VALLEYCREEK 1 COMPLIANCE PACKAGE "A1"

PROJECT NAME
RUSSELL GARDENS III

AREA CHARTS

FIRST FLOOR PLAN 3

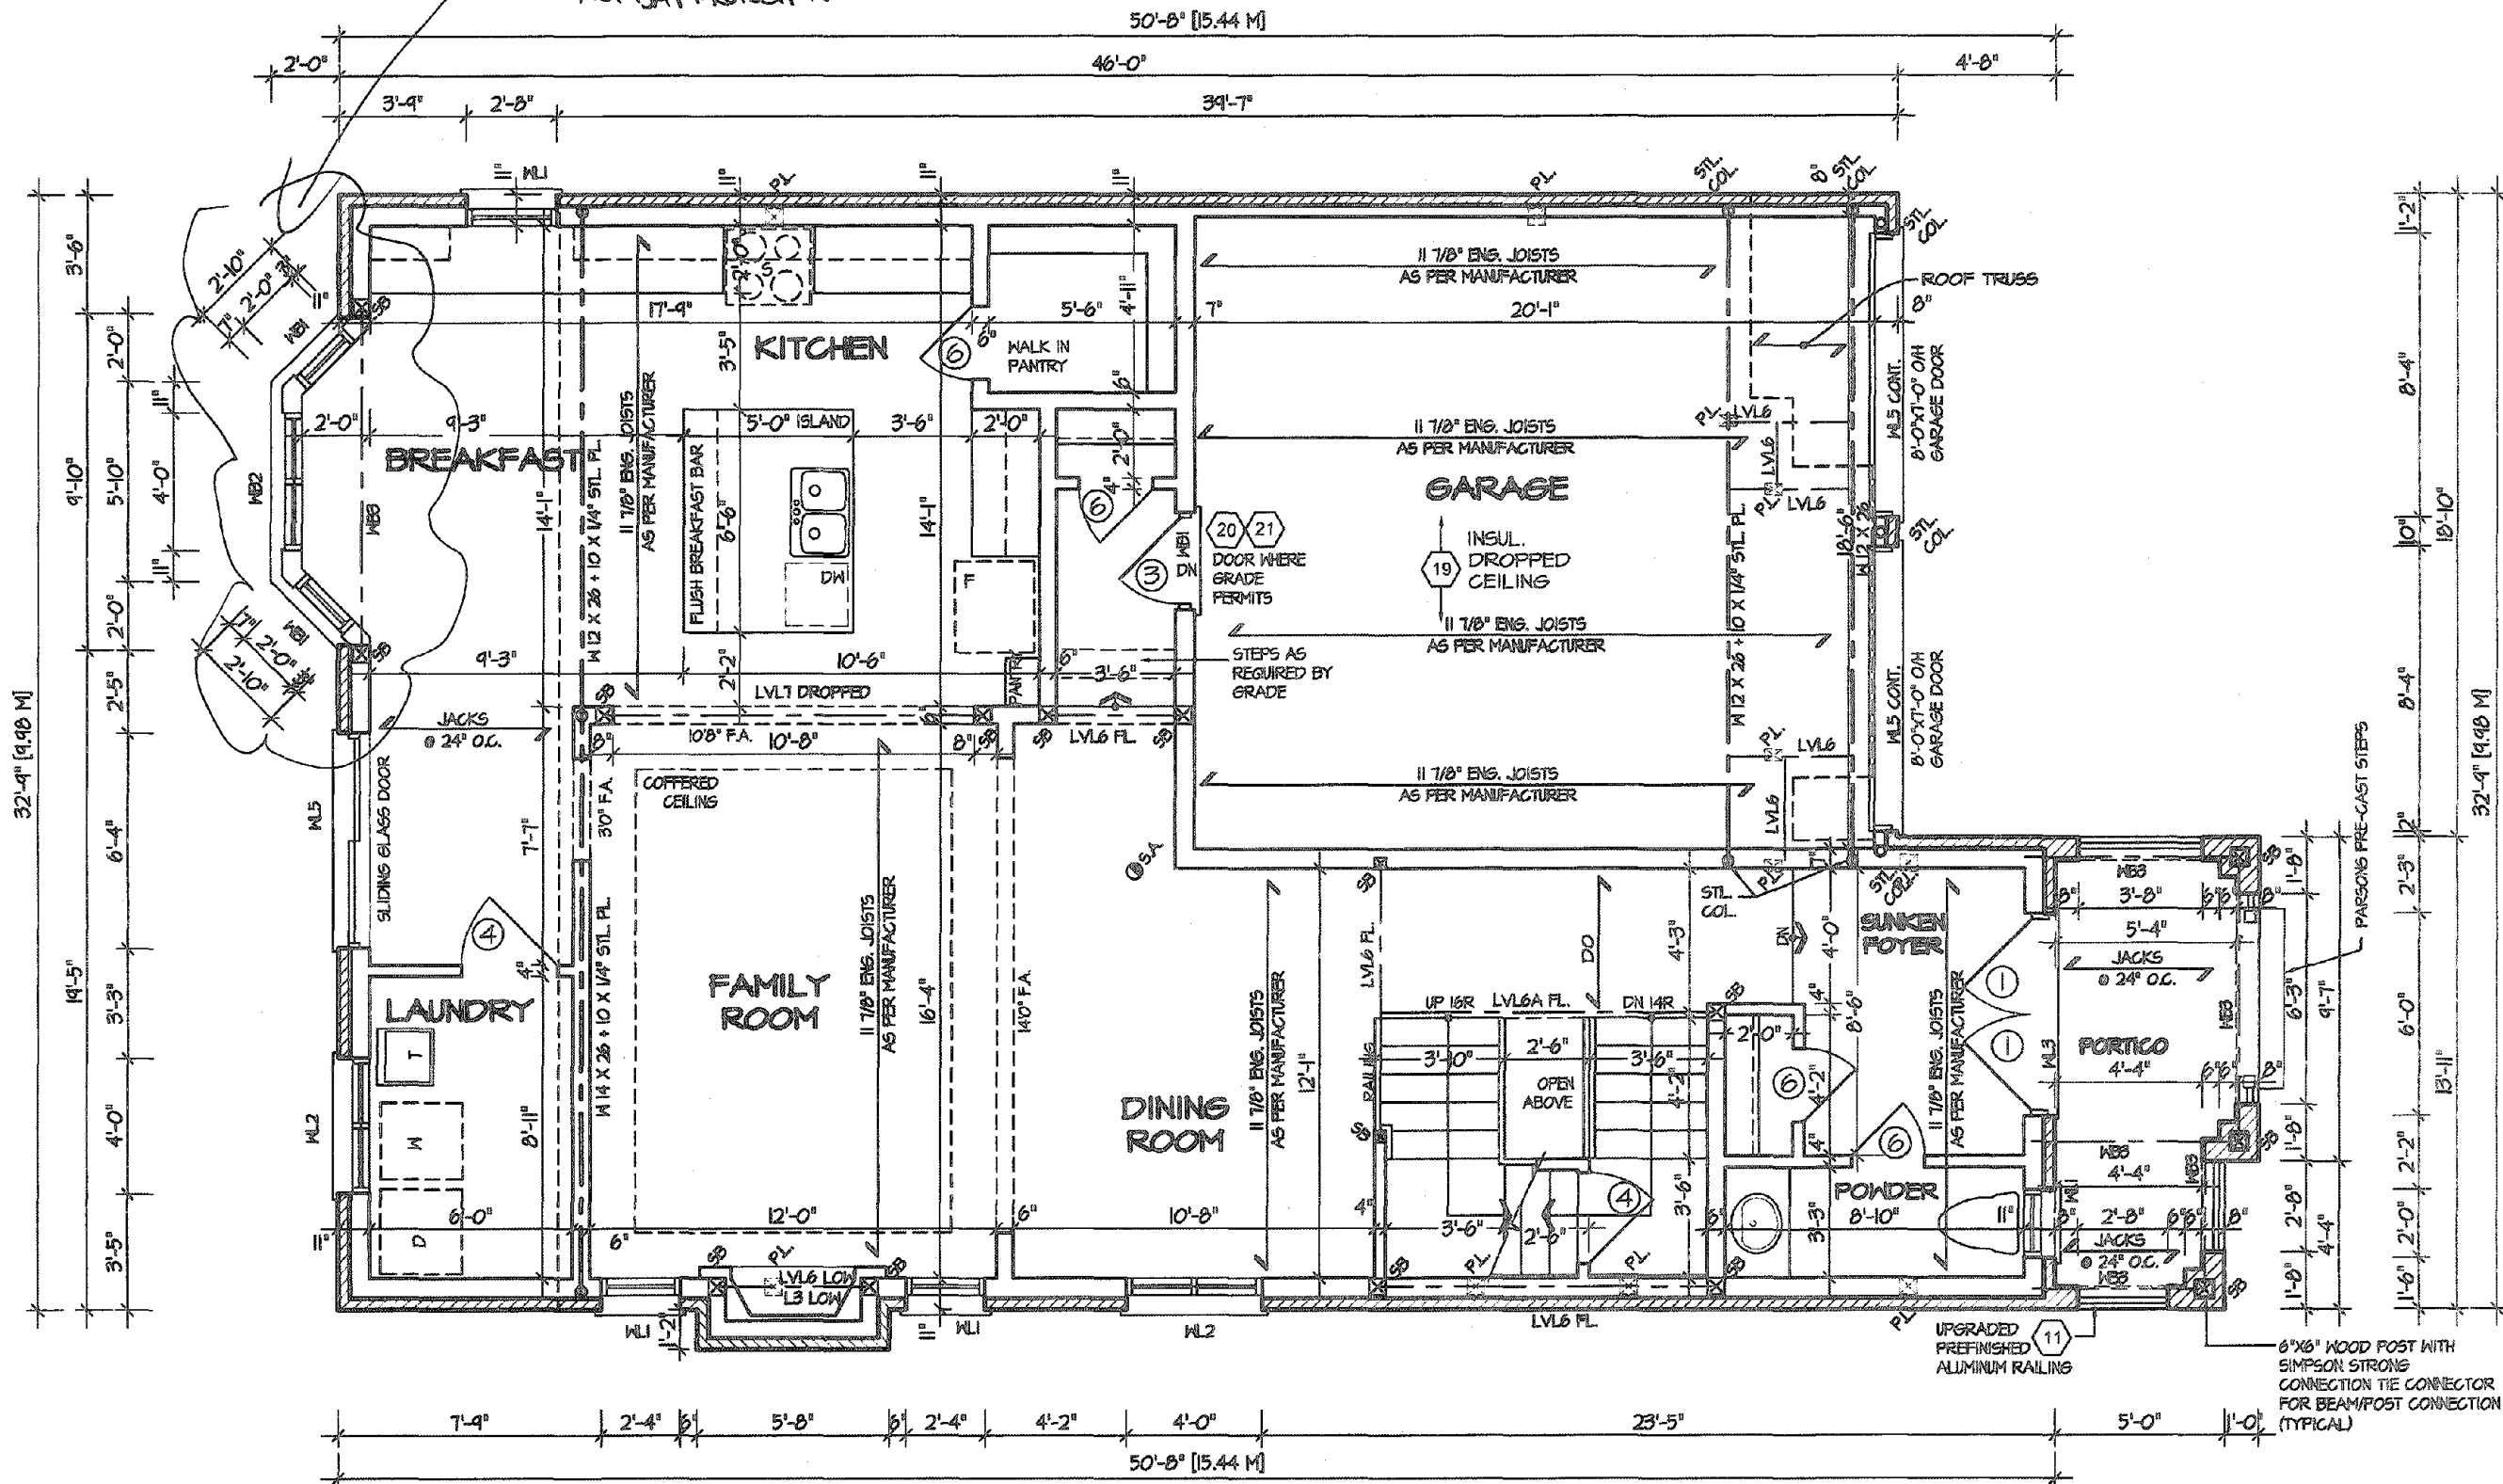
AREA OF REVISION
MUST BE BAY WINDOW
NOT BAY PROTECTION

PARTIAL BASEMENT PLAN
FOR DECK CONDITION
1, 2 & 3

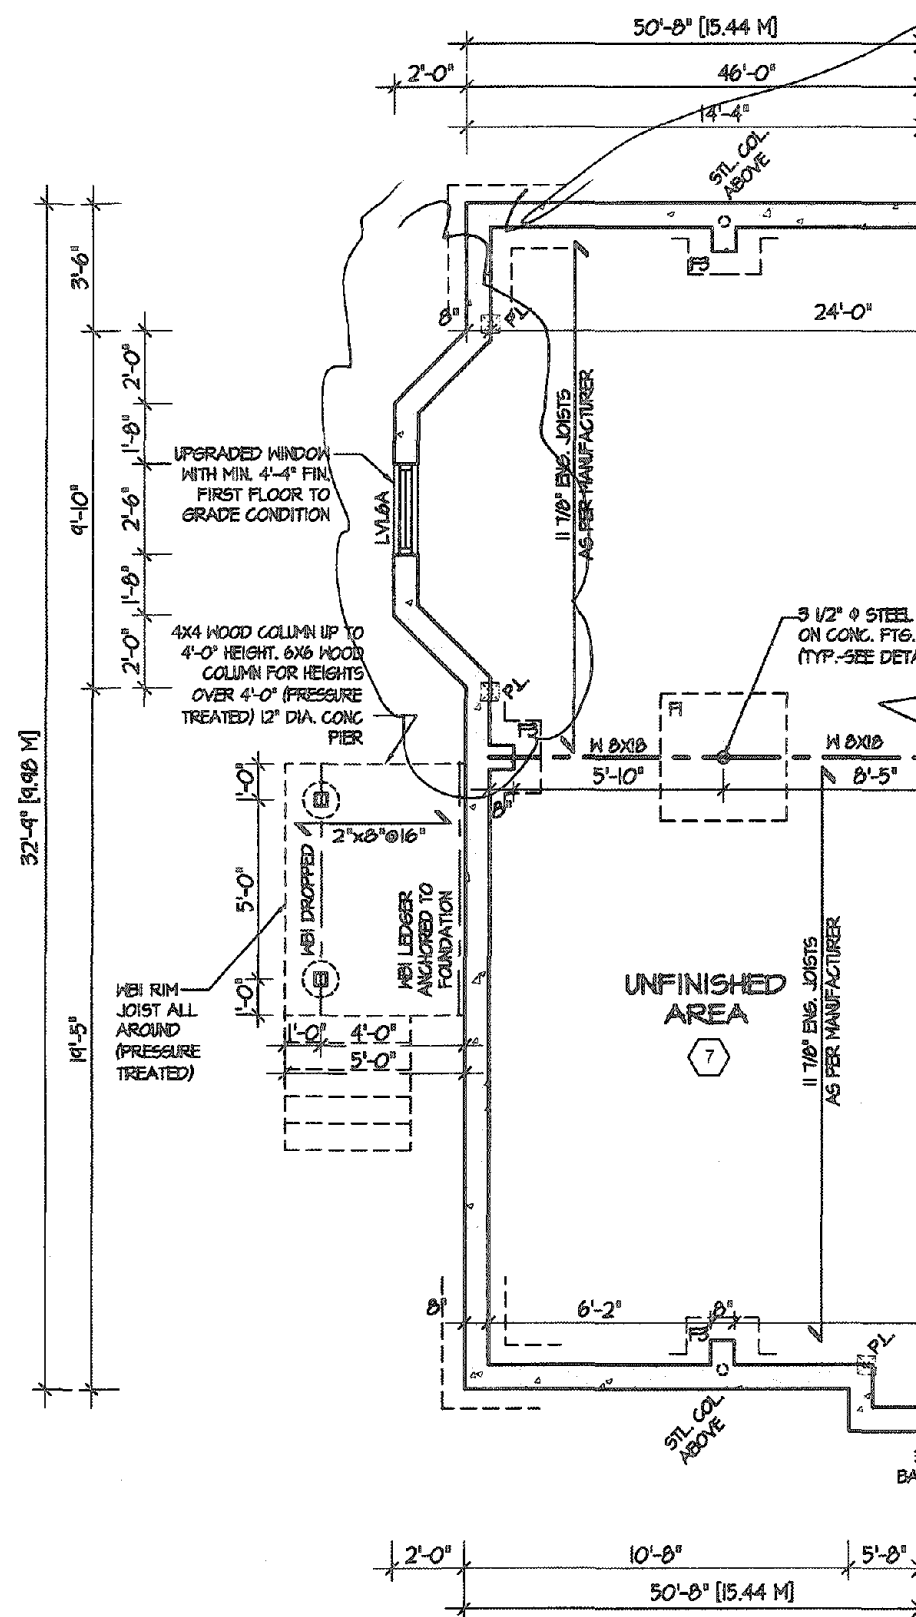
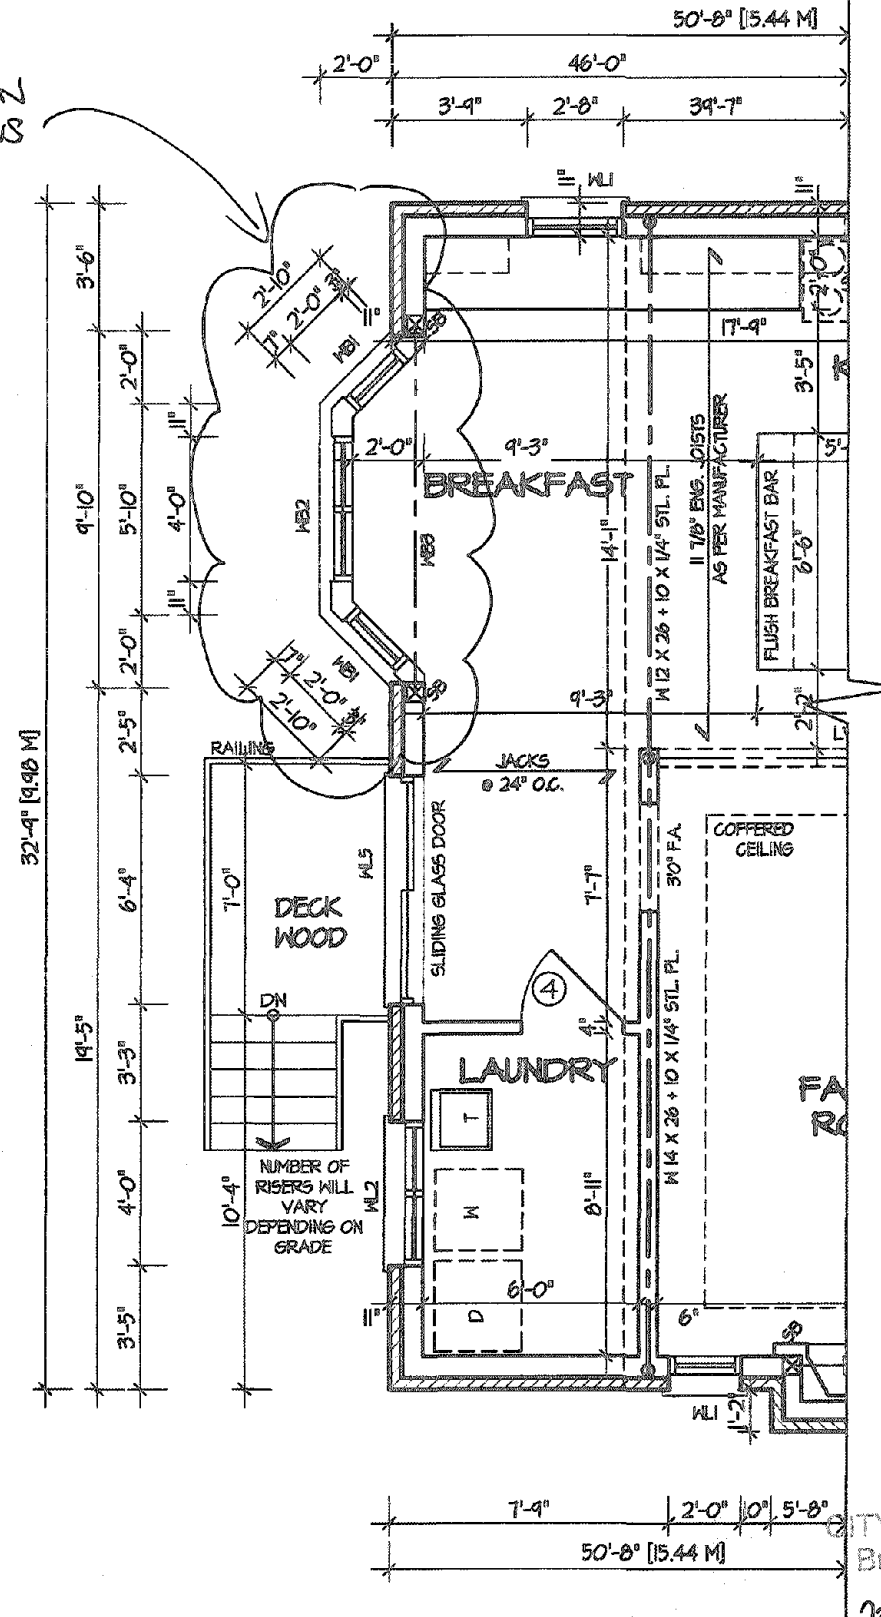
AREAS OF REVISION
MUST BE BAY WINDOWS
NOT BAY PROJECTIONS
